Monday, October 30, 2017
Medway Planning and Economic Development Board
155 Village Street
Medway, MA 02053

143 Village Street Special Permit – Public Hearing Continuation

**GRADING, UTILITY AND
EROSION CONTROL PLAN**

**MULTI FAMILY HOUSING
SPECIAL PERMIT
143 VILLAGE STREET
MEDWAY
MASSACHUSETTS**

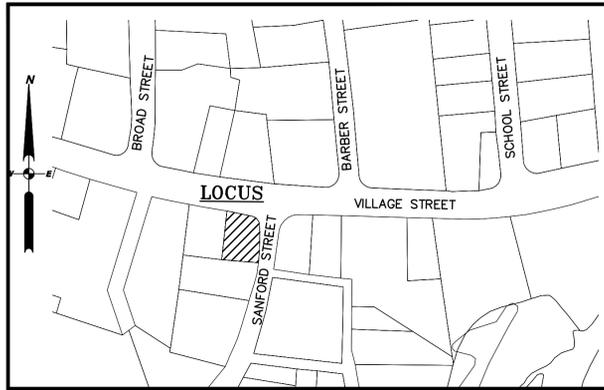
Steve and I took a look at the plan and don't share Dale's concern regarding the size of the curb radius. Curb radii at intersections are frequently smaller than 38.6'. Trucks turning onto Sanford from Village have more than enough travel lane to make the turn safely since they are able to track a wider line closer to the roadway centerlines.

What G&H shows will work, however a more typical layout would have a single curve connecting the curb lines of Sanford and Village. The attached figure shows 3 radii options worth considering. The 42' radii will not work since there isn't enough room to keep sidewalk in the public ROW.

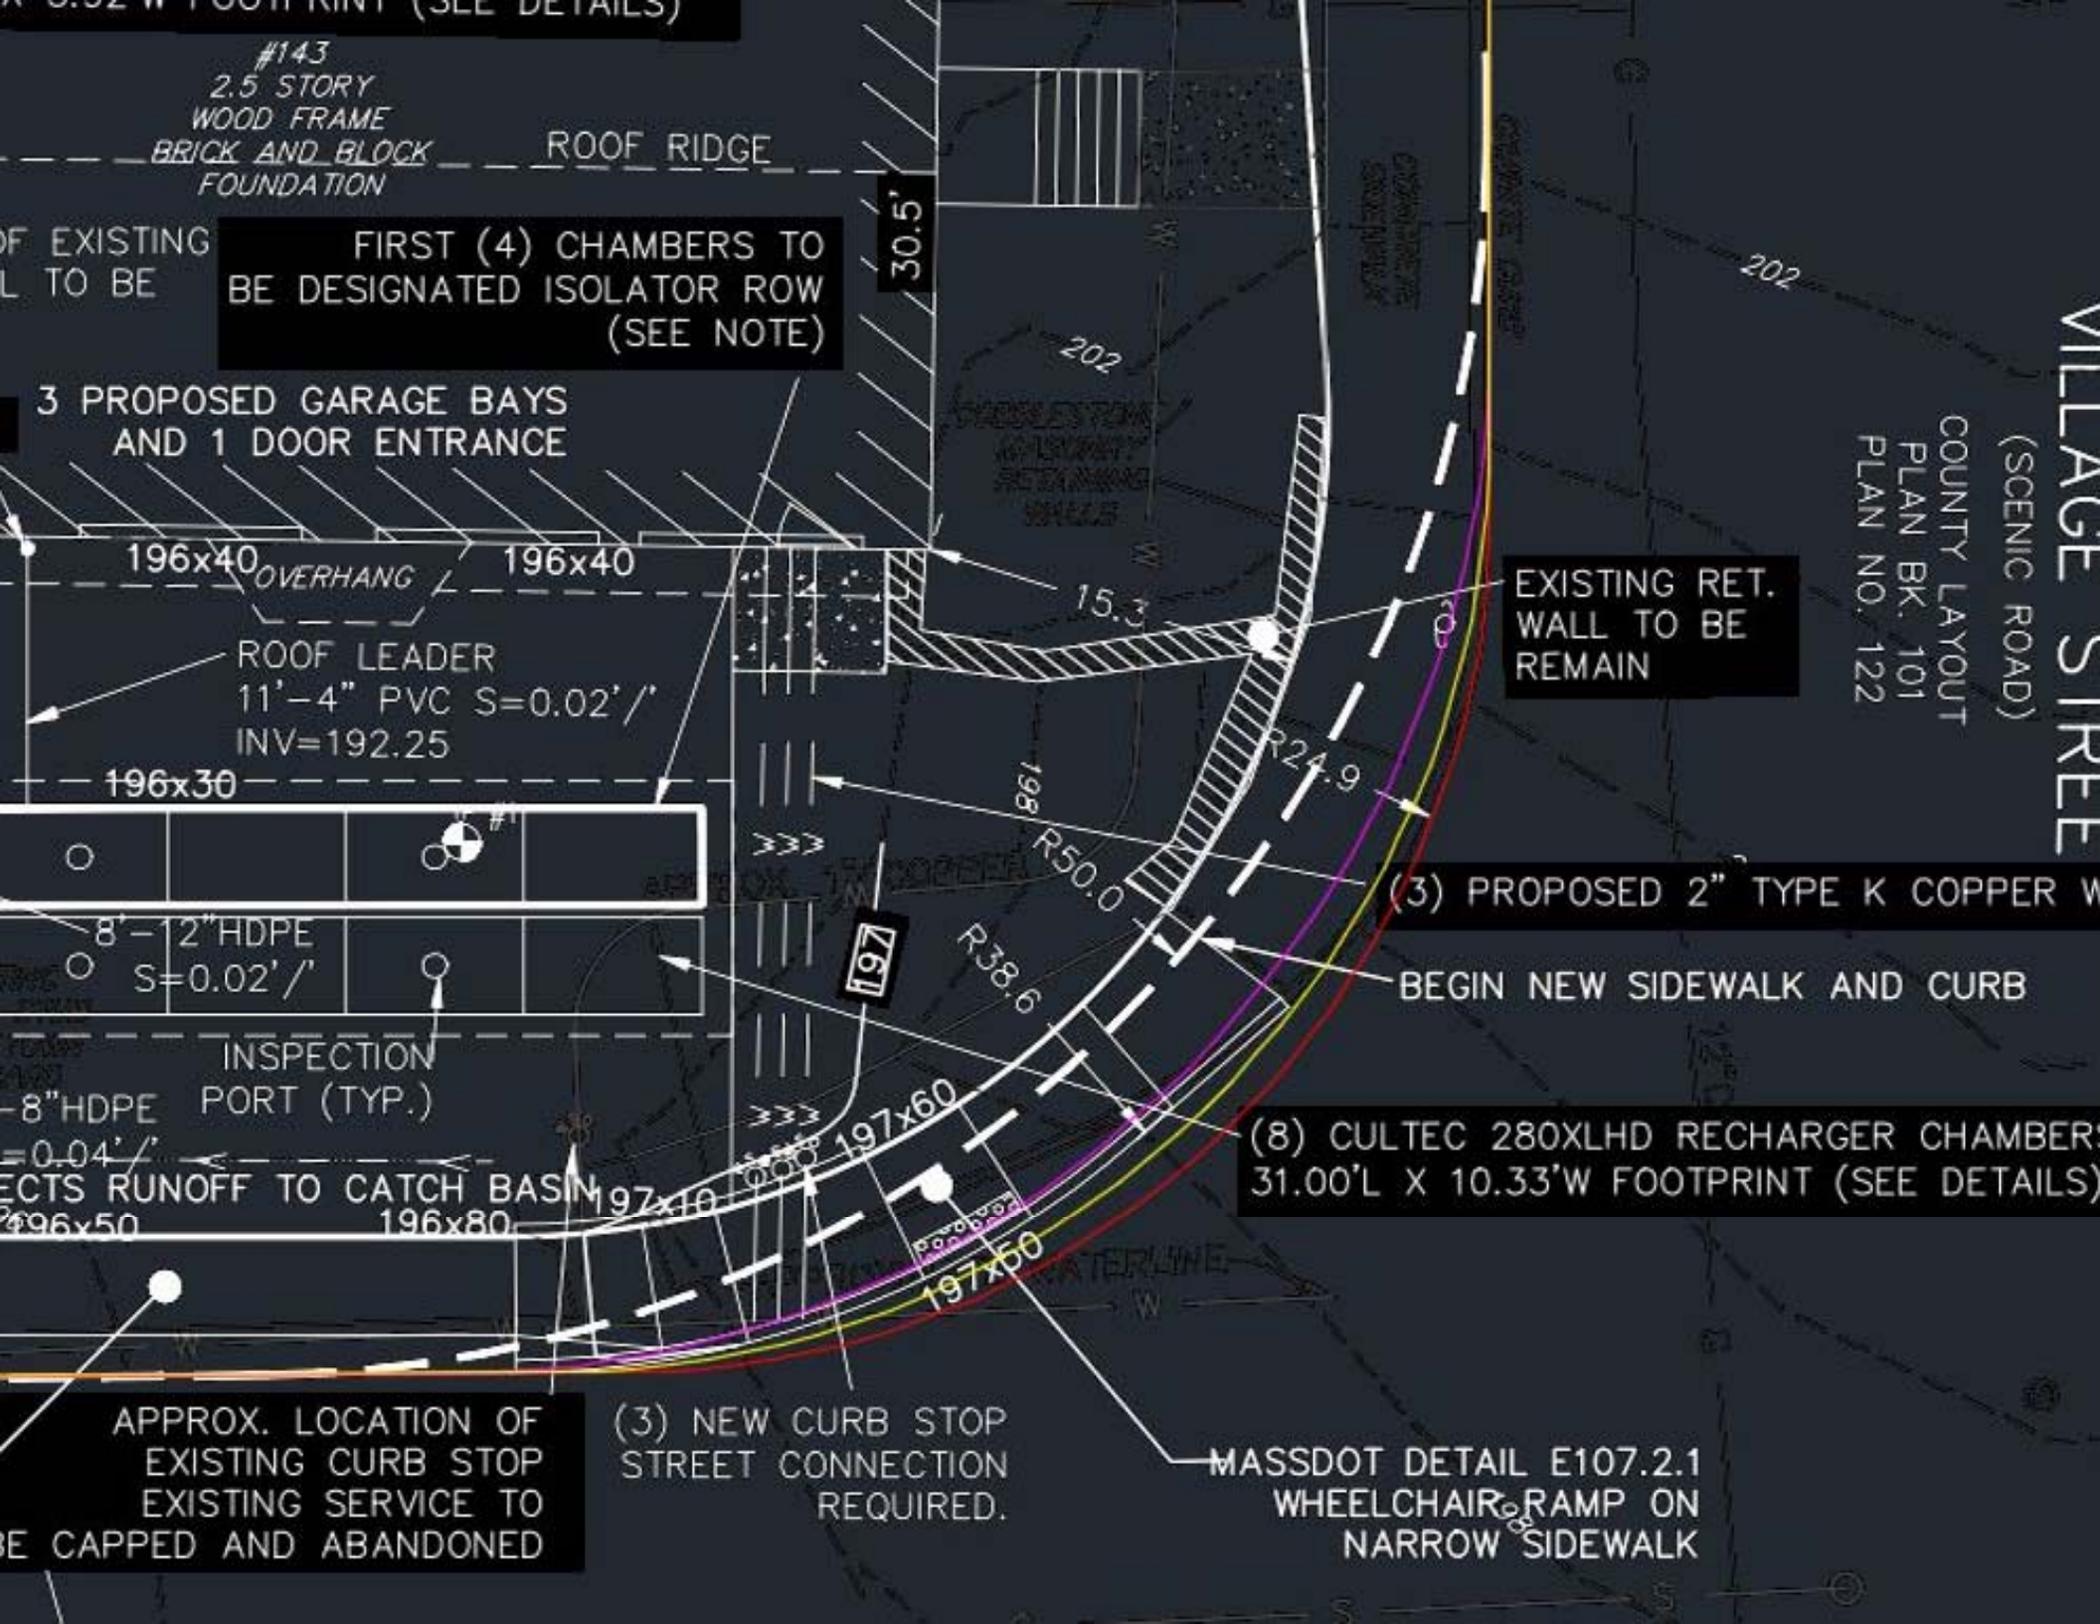
There was a meeting with the applicant, Susy, DPS Director Dave D’Amico and DPS Highway Superintendent Jack Tucker on Thursday, 10/26/17. Engineering consultant Sean Reardon joined by conference call. The discussion focused on the curb at the southwest corner of the intersection of Sanford and Village Streets and truck traffic and the location of the sidewalk. The Board wants to get the sidewalk off of private property and onto the Town right-of-way. The group reviewed the revised grading, utilities and erosion control plan and details. A corner radius of 50 ft. was discussed with a sidewalk of 5 ½ feet at the back edge of existing corner. There was discussion that the radius should not be smaller than 38.6 ft.

The Board discussed an email communication from Sean Reardon on 10/26/17 in which he recommended a 35 ft. corner radius in order to slow down traffic turning the corner from eastbound Village to southbound Sanford Street.

The plan will show a 35' radius with the understanding that it may be modified in the field upon consultation with Safety Officer Sergeant Jeff Watson.

The applicant was reminded to check the layout for the ramps and crosswalks which must line up when going across Sanford Street. The tactile strips also need to line up for blind residents.

4. Revise and reduce the turning radius of the southwest corner of Sanford and Village Streets
 5. Relocate sidewalk away from private property and into the right of way. Denote who is responsible for sidewalk construction. Sidewalk construction shall be ADA/AAB compliant.
